PRODUCT CHANGE **NOTIFICATION**

Bourns® SRR1210 and SRR1210A Series Shielded Power Inductors

Change in RI Core Design

IC26140

Existing RI Core	Revised RI Core

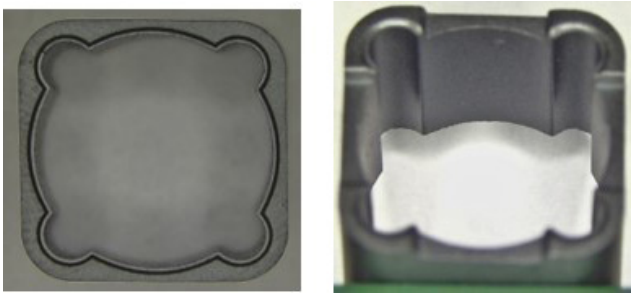
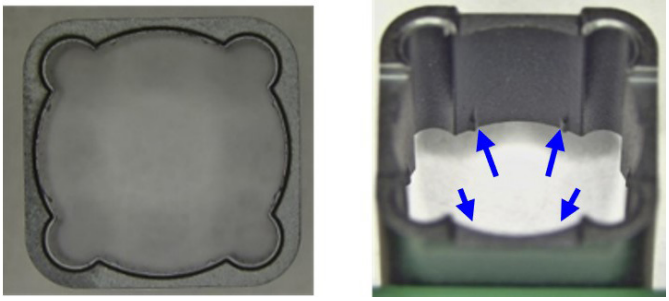
Riverside, California – August 19, 2026 – As part of our continuous improvement efforts, effective June 1, 2027, Bourns will change the RI Core design for the SRR1210 and SRR1210A Series Shielded Power Inductors. A positioning structure will be added to the RI core to enhance structural robustness. A list of affected part numbers is included below.

The form, fit, and function of the finished products will remain the same. The quality and reliability of the inductors should be improved. Traceability will be maintained through lot code and date code.

Date that products manufactured with the current RI core will cease: ***2027-05-31***
Date that deliveries of products manufactured with the new RI core angle will begin: ***2027-06-01***
First date code using the above changes ***2722***
